**AGENDA**  
**CITY PLANNING COMMISSION**

City Hall - Council Chambers  
6131 Taylorsville Road  
August 15, 2023  
6:00 P.M.

To: Huber Heights City Planning Commission  
From: Aaron K. Sorrell, City Planner  
Date: August 8, 2023  
Subject: MC 23-20 Kettering Health Center Minor Change (helistop)

To: Huber Heights City Planning Commission  
From: Aaron K. Sorrell, City Planner  
Date: August 9, 2023  
Subject: Detailed Development Plan: DDP 23-21  
(Flying Ace Car Wash – 7730 Brandt Pike)

**SITE PLAN**

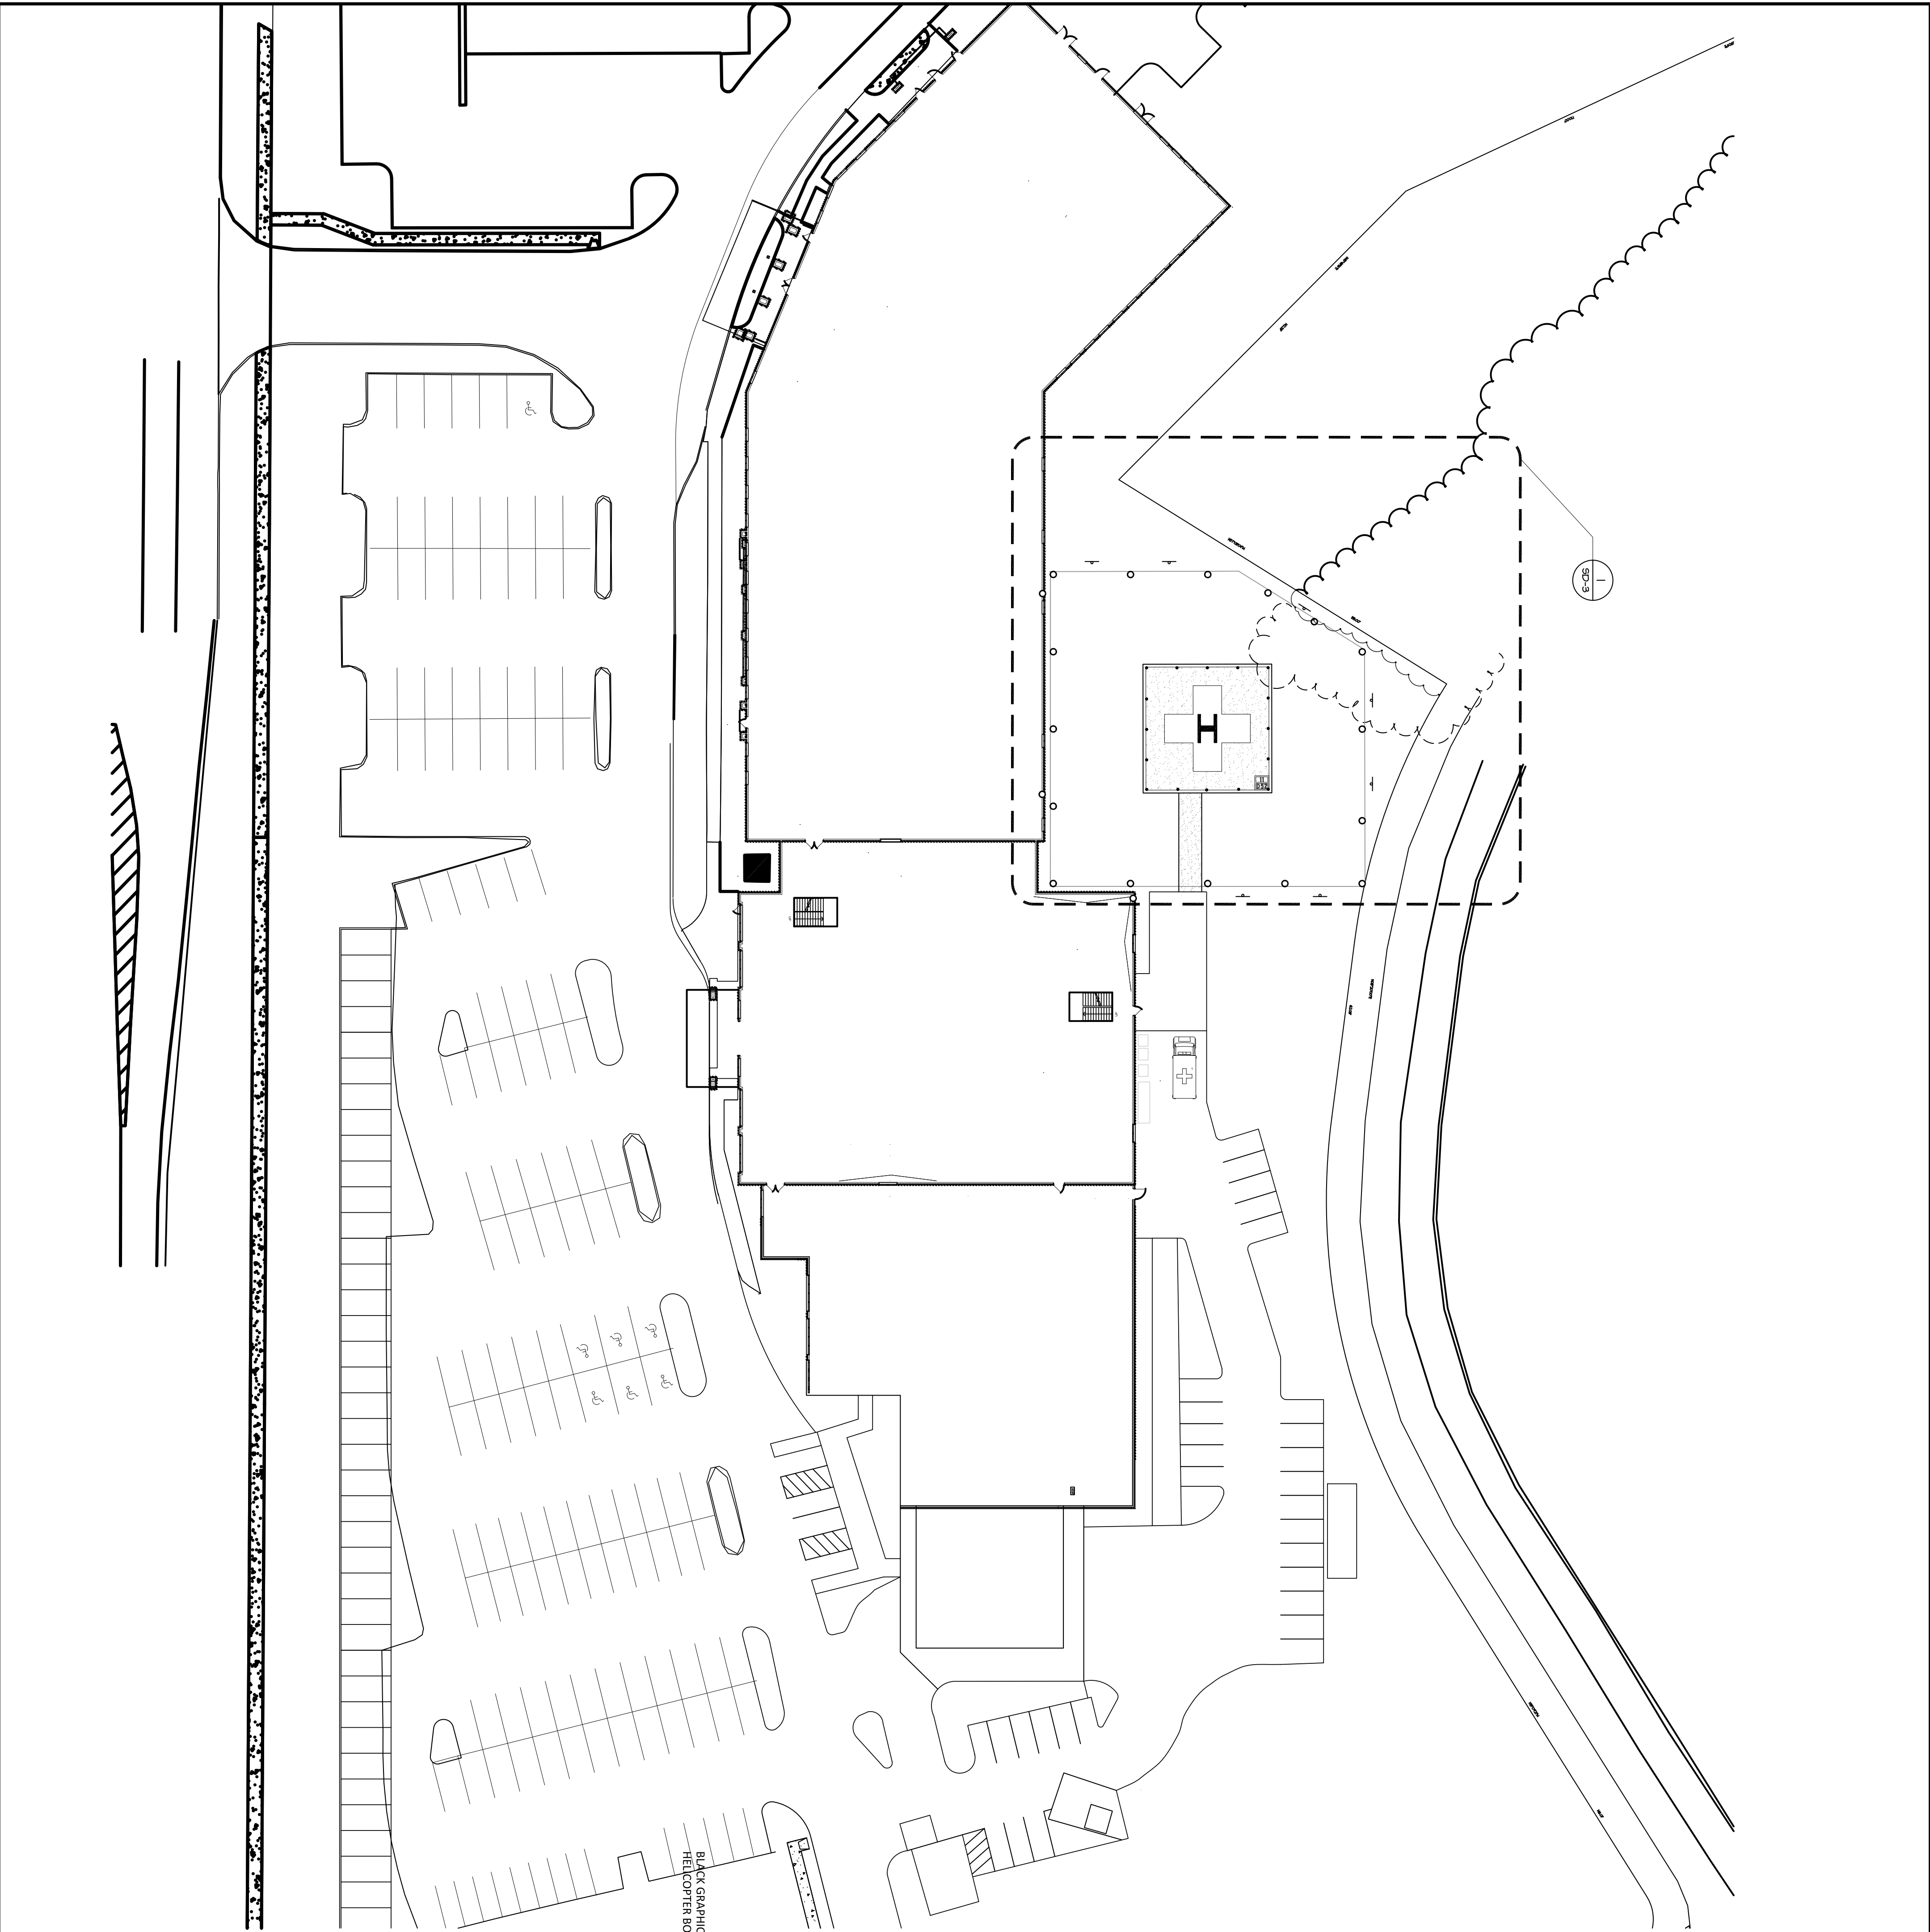
- Driveways are existing and there do not appear to be any changes.
- These plans do not indicate any type of refueling system for the aircraft. If a refueling center is planned additional requirements and reviews will be required.
- Clearances for the pad shall comply with Ohio Fire Code 2007.2.
- Fire extinguishers complying with Ohio Fire Code 2007.7 shall be provided.
- Approval from the Federal Aviation Administration shall be obtained. Ohio Fire Code 2007.8.
- A permit shall be obtained for construction from Montgomery County Building Regulations.

SITE/UTILITY PLAN  
FLYING ACE CAR WASH  
7730 BRANDT PIKE  
LOCATED IN  
SECTION 17, TOWN 2, RANGE 8 M.Rs.  
CITY OF HUBER HEIGHTS, MONTGOMERY COUNTY, OHIO

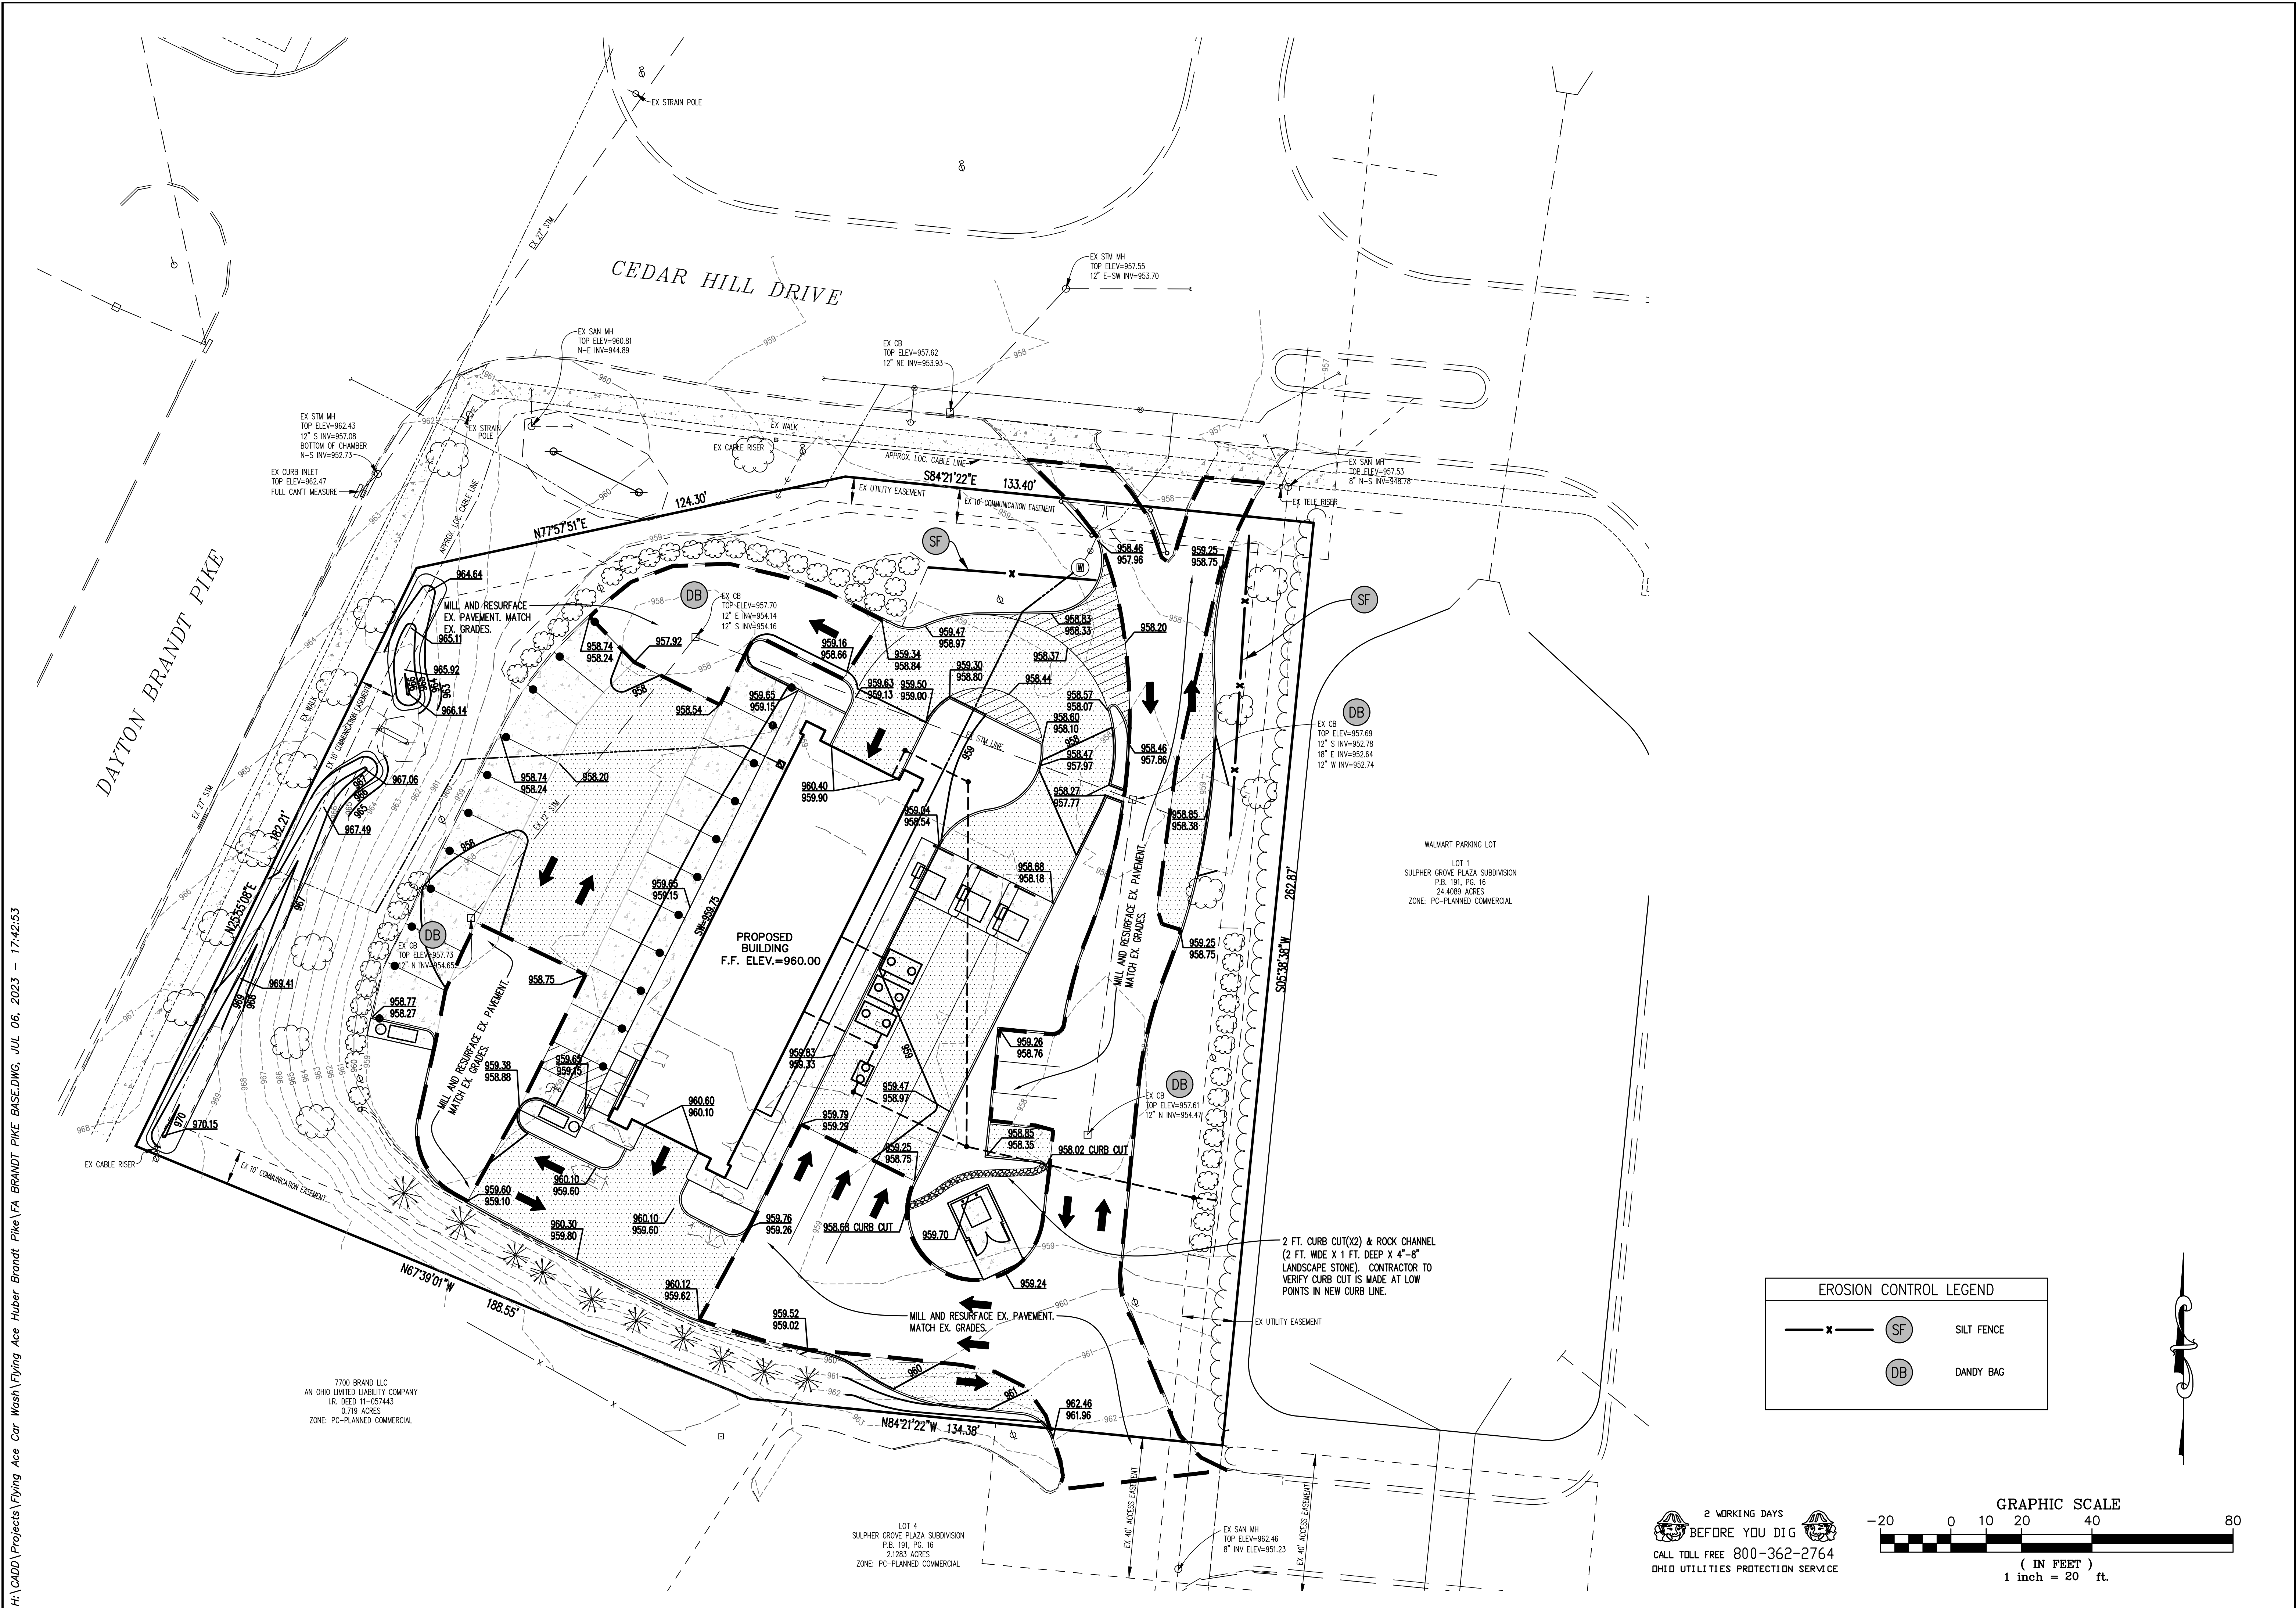
**A gate shall be installed at the Cedar Hill Drive entrance.** A swing gate at the Cedar Hill Drive entrance is illustrated on the site plans.

While the DDP does not enumerate the number of waiting spaces, the Basic Development Plan indicated up to 51 queuing spaces. The DDP circulation and parking plan is identical to the approved Basic Development Plan (BDP). Staff feels the number of waiting spaces is adequate and meets the code.
